# **HEGER DRY DOCK, INC**

Re: Request for HEGER Certification of Dry Dock No. 2 located in BAE San Francisco, CA

In order to issue a commercial capacity certification for Dry Dock No. 2, Heger Dry Dock conducted a design review to establish operational limitations based on the dock's current condition.

The objective of this letter is to present the results of HEGER's design review. The review outlines the dry dock's limitations and notable structural deficiencies of the dock's current condition. The design review includes:

**FIGURE 1 – Intact Stability Curve**

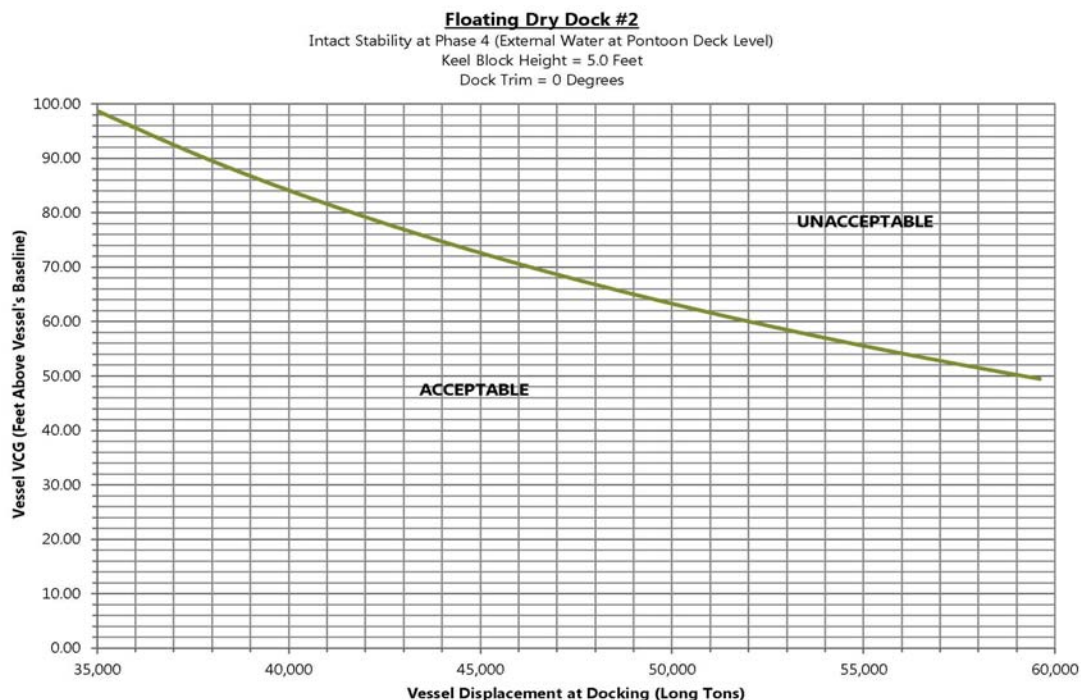
Dry Dock No. 2 was renovated in 2008 by adding six (6) 40'x12' sponsons in order to increase its transverse intact stability for docking phases 3 and 4. HEGER has developed an allowable KG versus vessel weight curve for the floating dry dock for a minimum GM of 3.28 feet as required by ABS. The stability curve is shown Figure 1 below. Plotted points that fall on or below this line are acceptable, points above are unacceptable.

**FIGURE 2 - Allowable Head Pressure vs. Plate Thickness Curve**

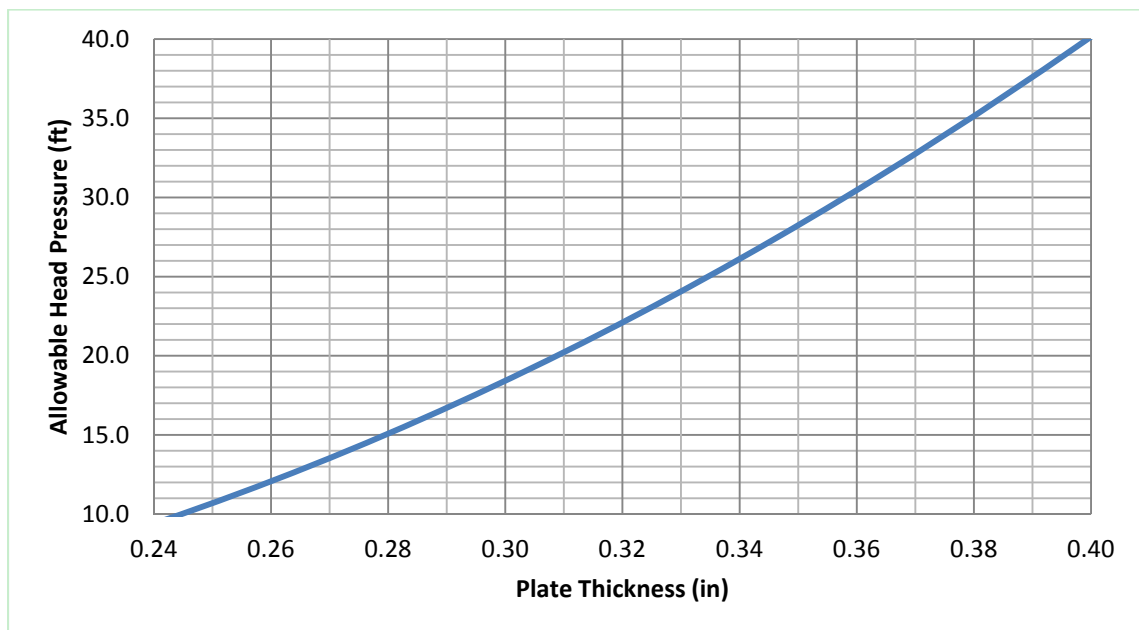
The results are as follows and are shown in Figure 2:

To create the chart in Figure 2, the assumption is that the angle stiffeners welded to the shell plate have 15% corrosion or less.

| DRAWING TITLE:<br><b>REPAIRS - PONTOON DECK - 1 OF 2</b>  |             |

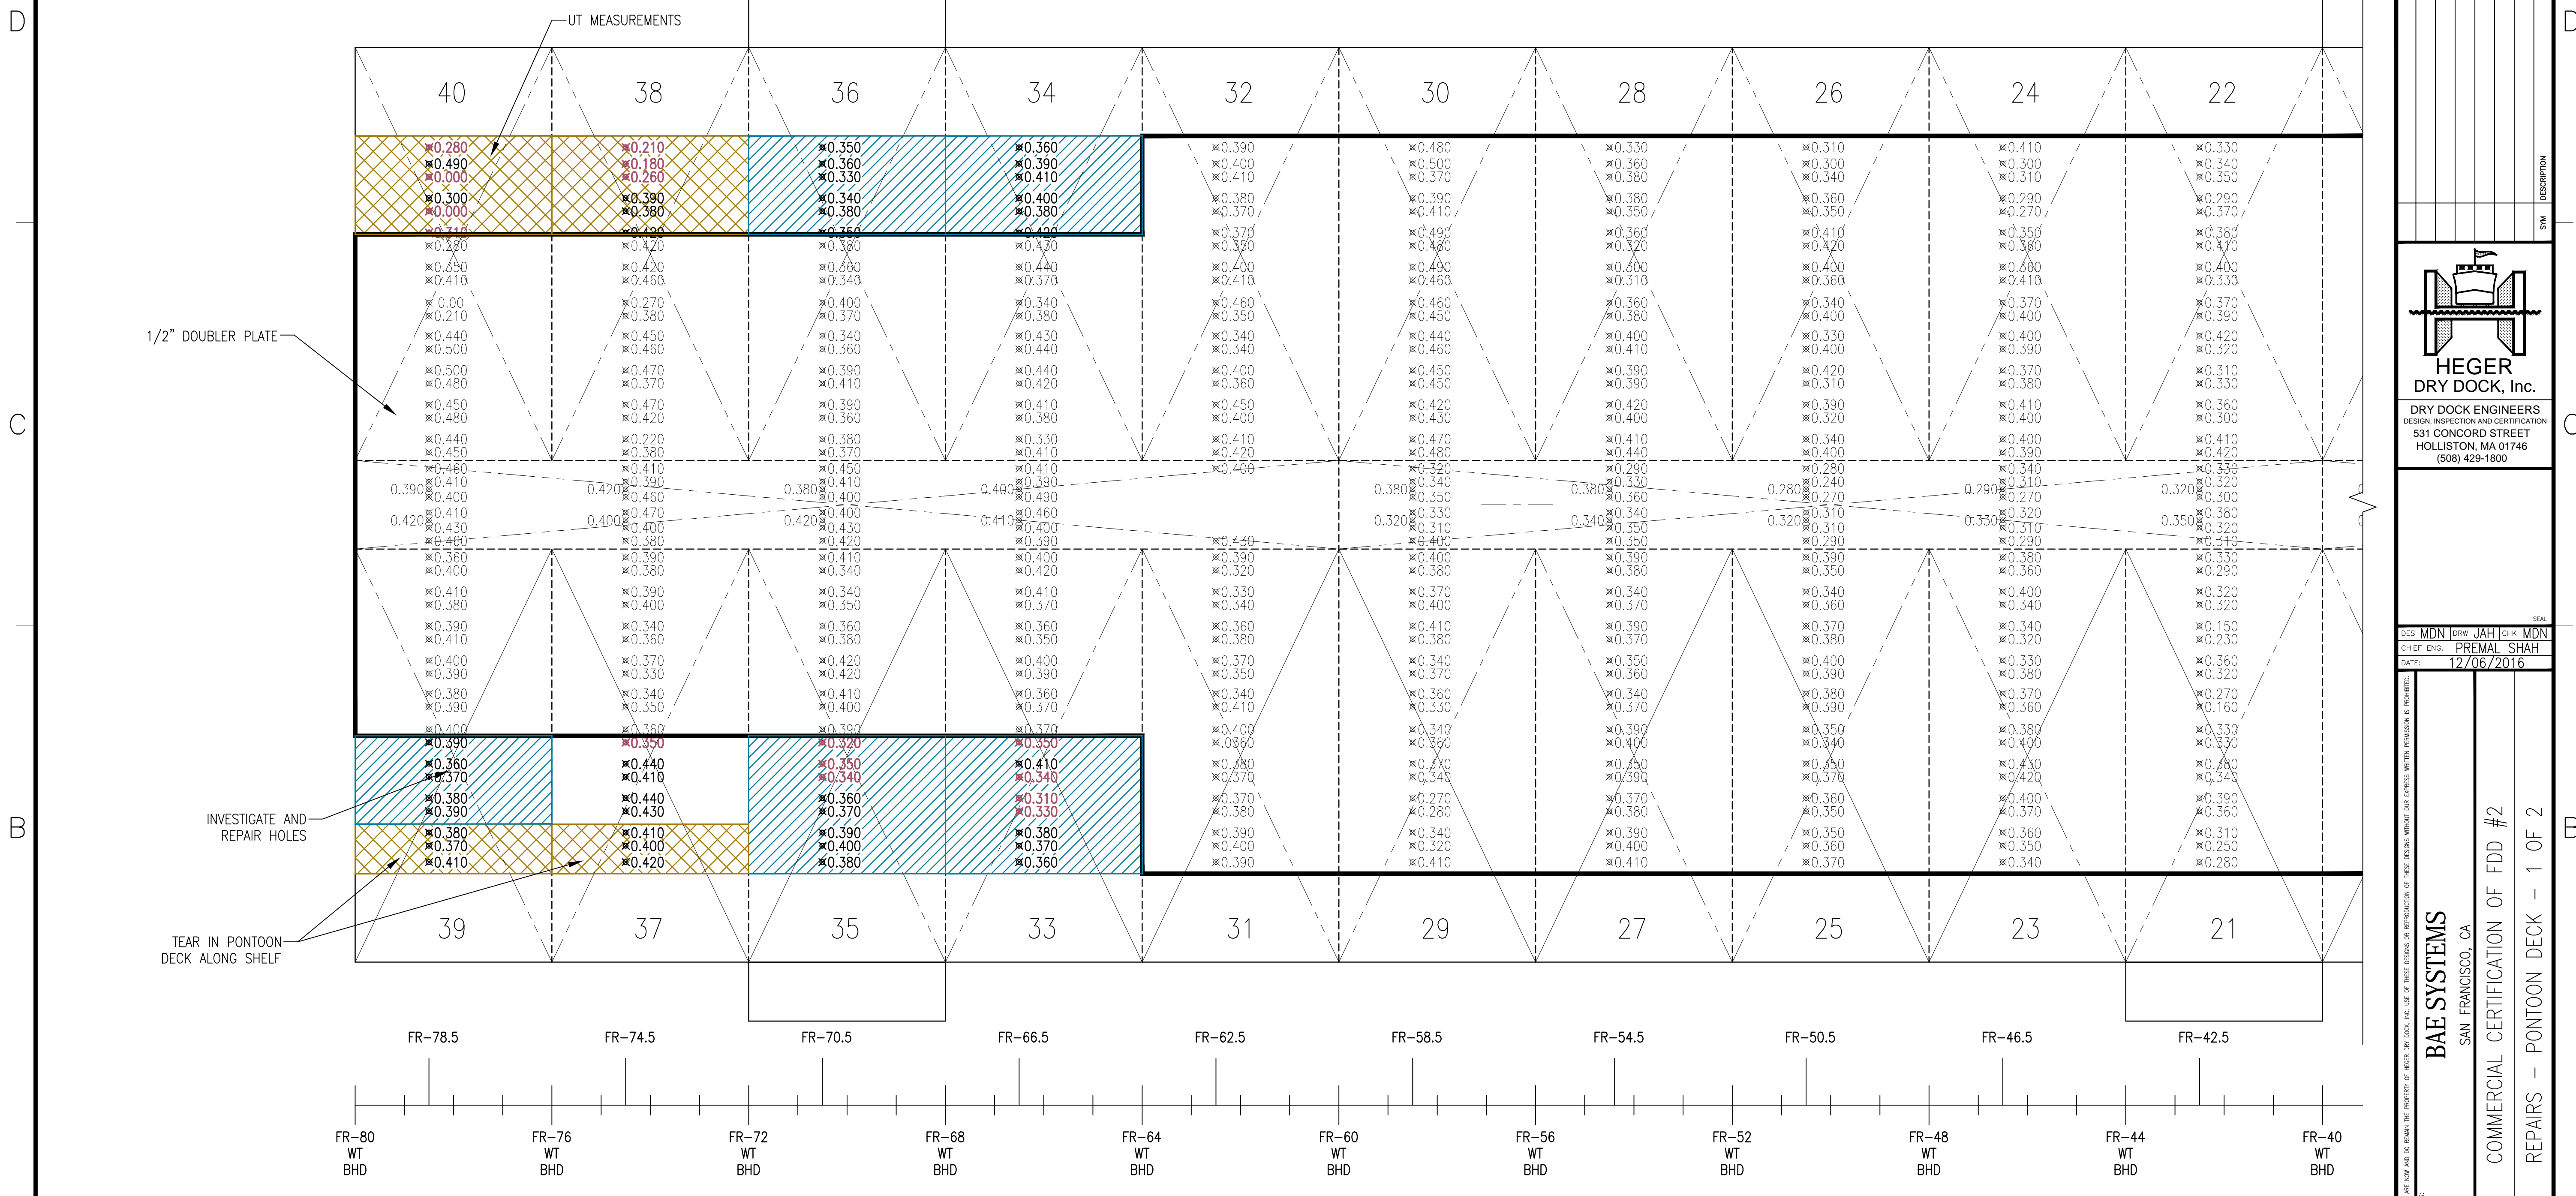
Based on HEGER's knowledge of the dock's design review, visual condition survey, and most recent UT survey, areas of the dock's structural deficiencies have been mapped out on the inboard and outboard wing shells and the pontoon deck in the drawings listed below. HEGER has assigned a Priority 1 or 2 to the areas of most structural concern.

**Priority 1** areas will need to be repaired prior to HEGER certification. These areas are either heavily corroded as indicated by the dock's UT survey or contain holes or other deficiencies noted in the 2016 control inspection.

In the drawings listed below, all areas are generally mapped out on a tank by tank basis. It is recommended the external shell in these areas be cropped out and replaced with a fabricated insert plate to properly repair the area. In the event of small isolated holes, a doubler plate may be installed as a temporary fix.

The majority of the pontoon deck has been covered with a 1/2" doubler plate. This is not a viable long term solution for the dock. HEGER recommends a maintenance plan be developed to properly replace the corroded deck panels with insert plates. Note that the dock was originally designed with 1/2" high strength steel (yield point of 50 ksi). HEGER recommends any pontoon deck replacements be 3/4" high strength steel. Note that this may correspond to a small reduction in the lift capacity of the dock due to an increase in dock weight, but will build in additional corrosion allowance.
